ADDENDUM NO. 1

2026 Hoffman Estates High School Locker Room Renovations and Palatine High School Auditorium Improvements

Date: October 8, 2025

**2026 LOCKER ROOM RENOVATIONS & MECHANICAL IMPROVEMENTS @ HOFFMAN ESTATES HS
TOWNSHIP HIGH SCHOOL DISTRICT 211
PROJECT NO. 25031**

MSK-001 (M7.0)
MSK-002 (M2.0)
MSK-003 (M2.1)
MSK-004 (M2.2)

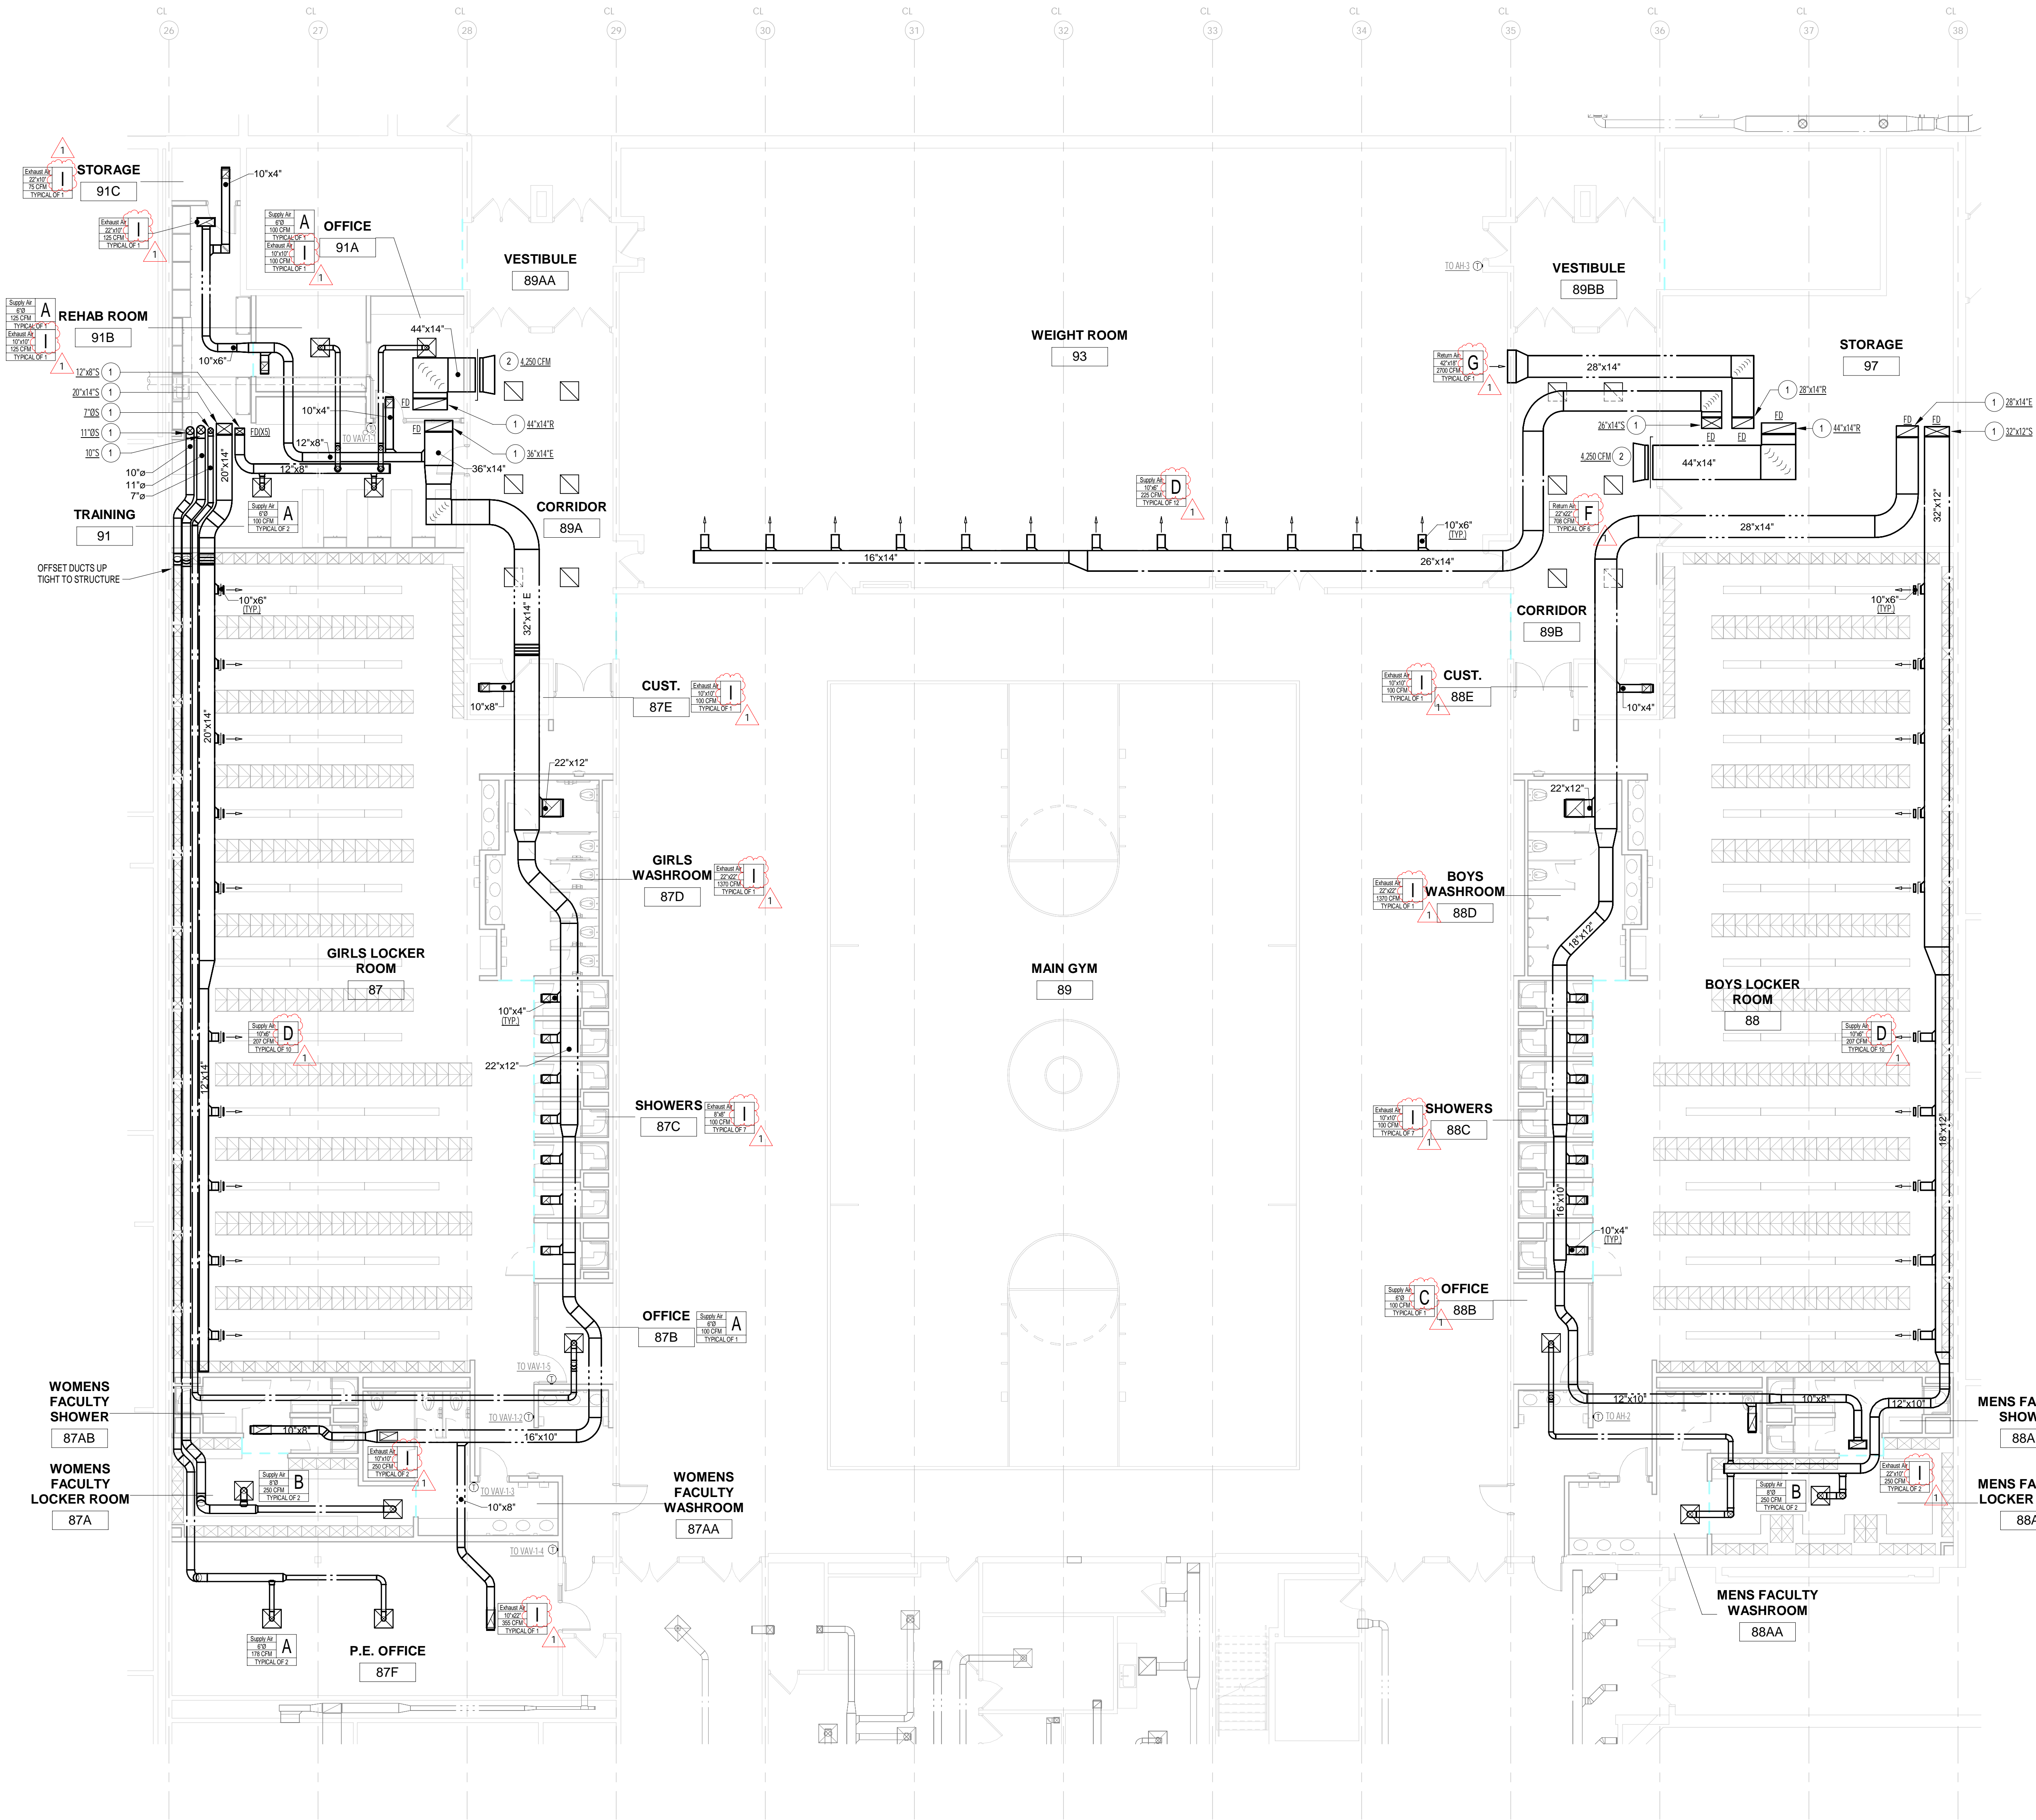
ITEM NO. 6: DRAWING, SHEET M7.0, MECHANICAL SCHEDULES

1. REVISE: At AIR HANDLING UNIT SCHEDULE
 - a) Add Schedule Note #14 to read; "AIR HANDLING UNITS (AH-1 & AH-2) HAVE HOT-GAS REHEAT (HGRH) AND REQUIRE AN ADDITIONAL COIL IN UNIT. COORDINATE COIL REQUIREMENTS WITH THE MANUFACTURER."
2. REVISE: At CONDENSING UNIT SCHEDULE
 - a) CU-AH1 REVISE "MECHANICAL COOLING STAGES (MIN)" to read; "25-100% (VARIABLE)".
 - b) CU-AH2 REVISE "MODEL" to read; "CFA-007".
 - c) CU-AH1 REVISE "MECHANICAL COOLING STAGES (MIN)" to read; "25-100% (VARIABLE)".
 - d) Add Schedule Note #13 to read; "CONDENSING UNITS (CU-AH1 & CU-AH2) HAVE HOT-GAS REHEAT (HGRH) AND REQUIRE AN ADDITIONAL COIL IN ASSOCIATED AHU AND AN ADDITIONAL LINE SET TO HGRH COIL. COORDINATE NUMBER OF LINE SETS AND SIZES OF LINE SETS WITH THE MANUFACTURER."
3. ADD: ADD "DIFFUSER SCHEDULE" in its entirety.

Sheet Title:
PARTIAL GROUND FLOOR
MECHANICAL PLAN

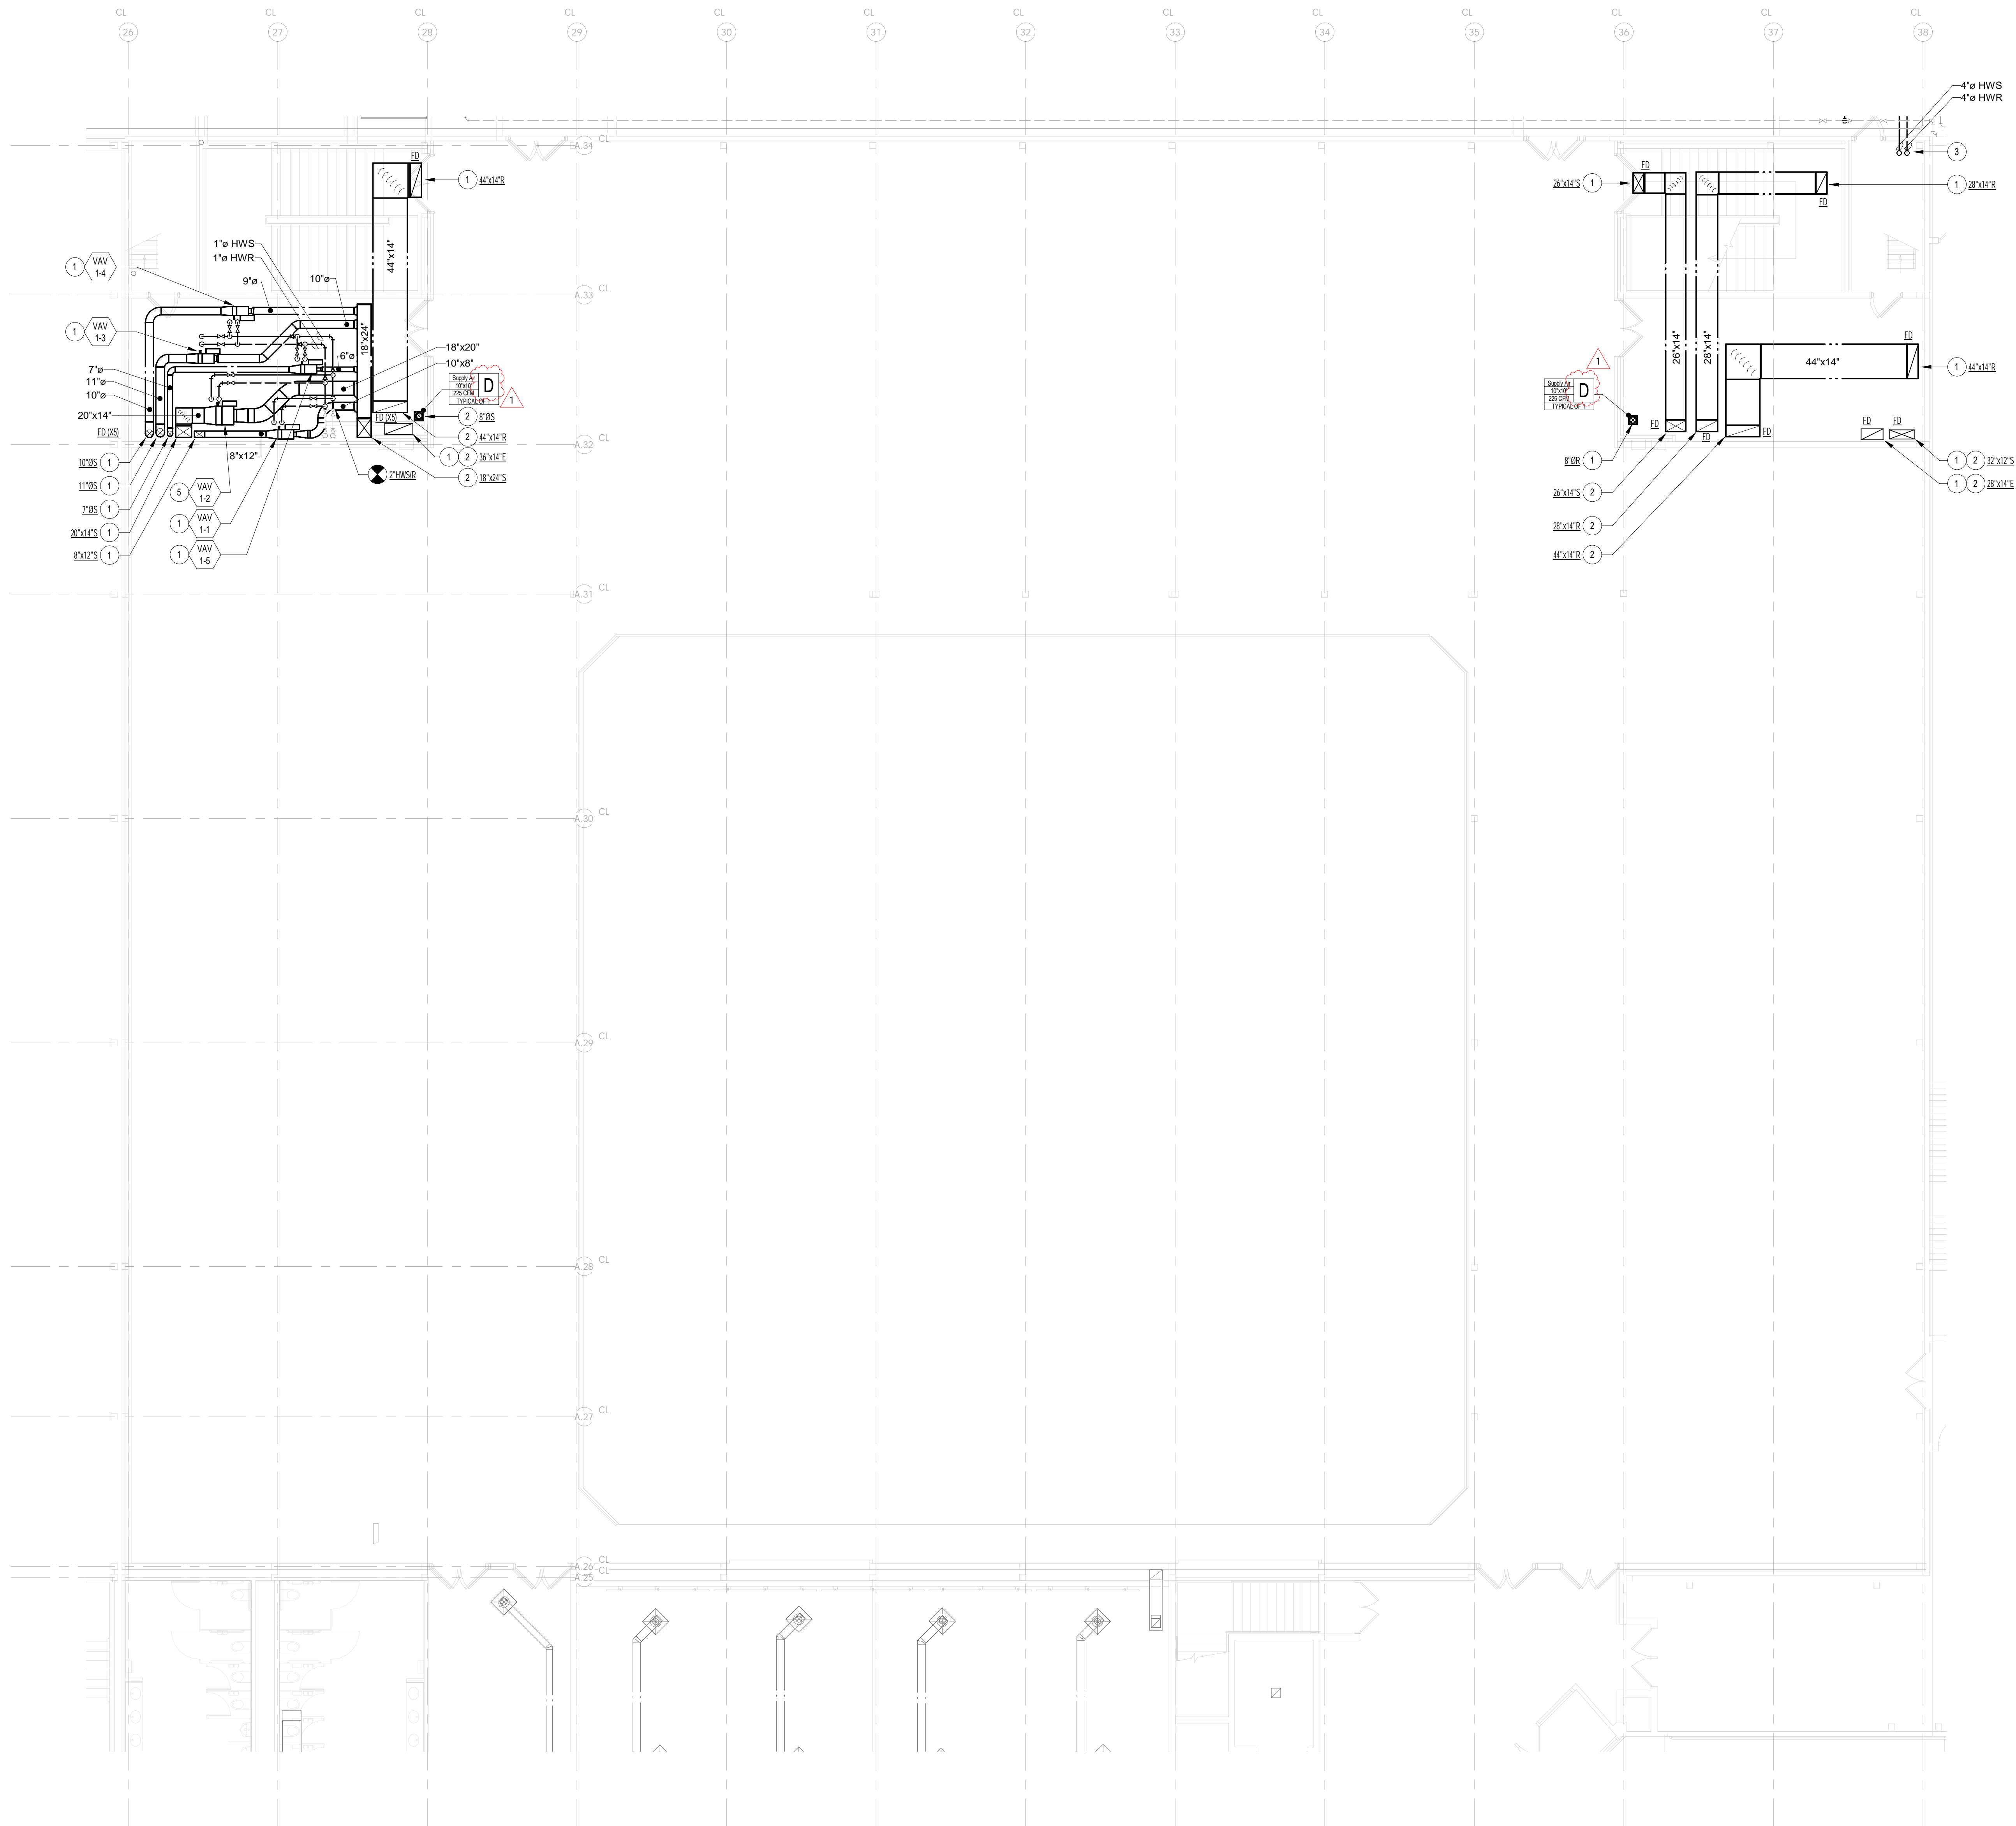
ITEM NO. 3: DRAWING, SHEET M2.0, PARTIAL GROUND FLOOR MECHANICAL PLAN

1. REVISE: REISSUE sheet to update several diffuser tags to correlate with the added DIFFUSER SCHEDULE on sheet M7.0.

Sheet Title:
PARTIAL FIRST FLOOR
MECHANICAL PLAN

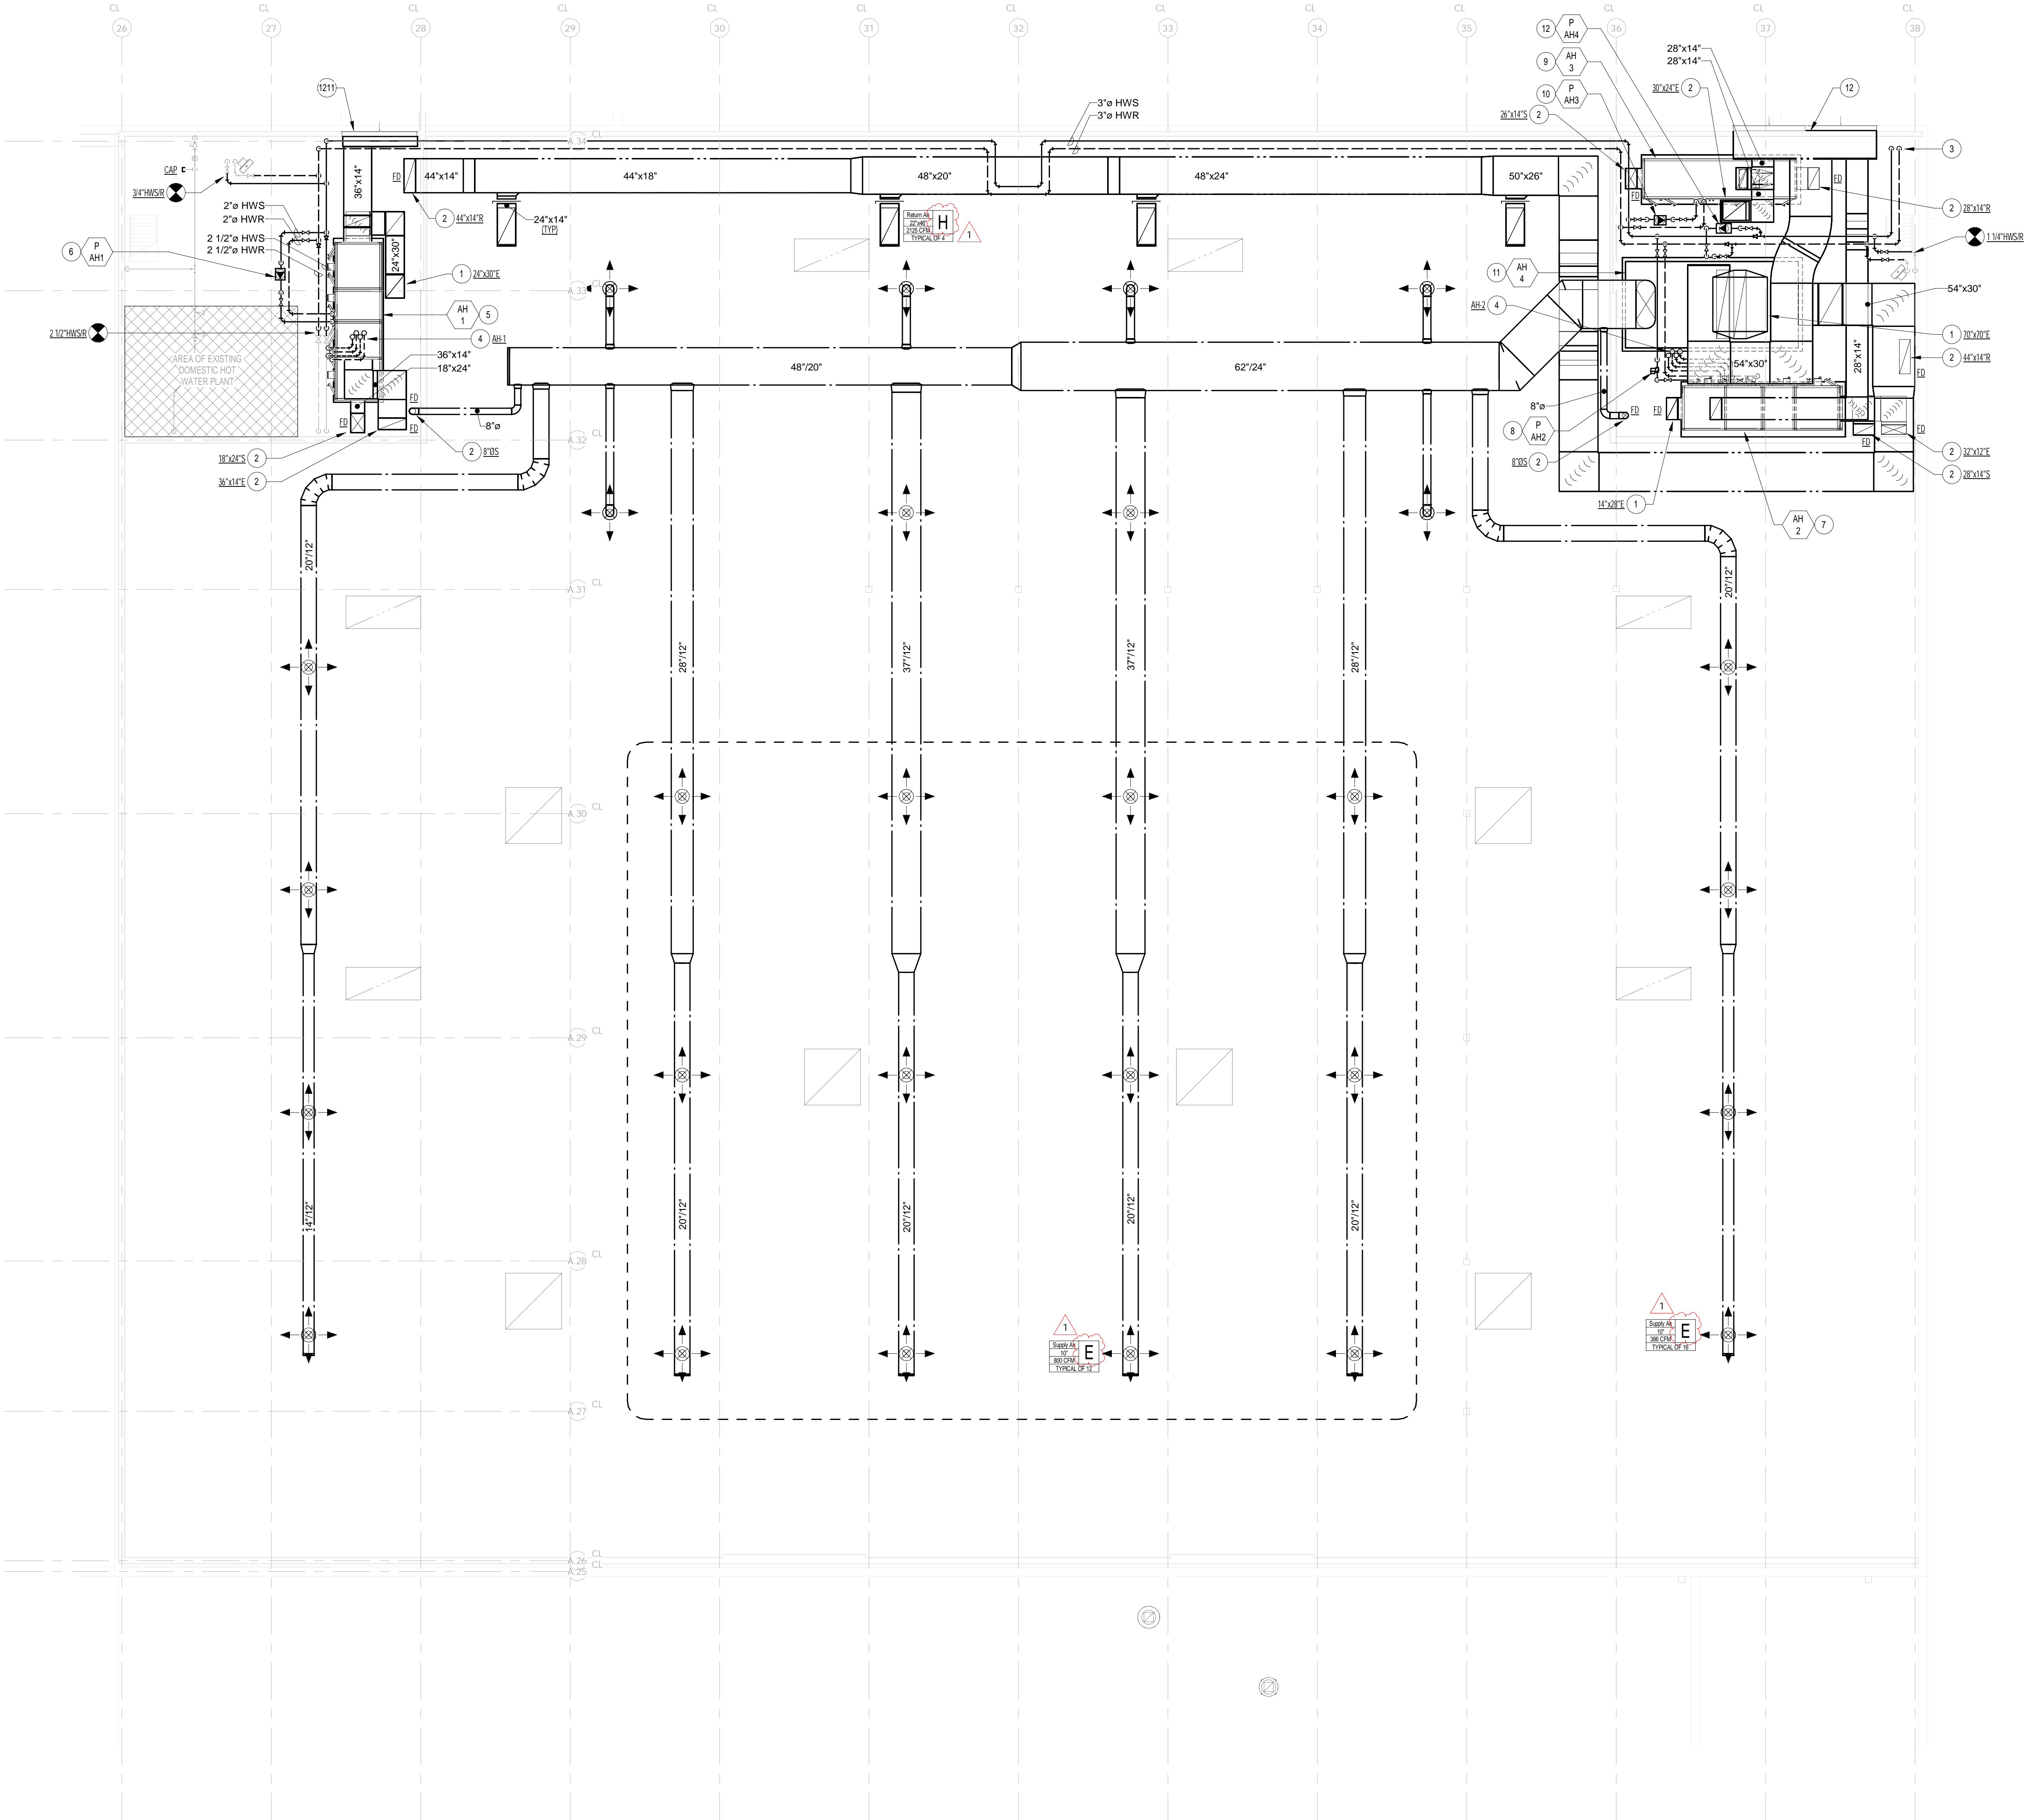
ITEM NO. 4: DRAWING, SHEET M2.1, PARTIAL FIRST FLOOR MECHANICAL PLAN

1. REVISE: REVISE sheet to update the two (2) diffuser "H" tags to tag as "D".
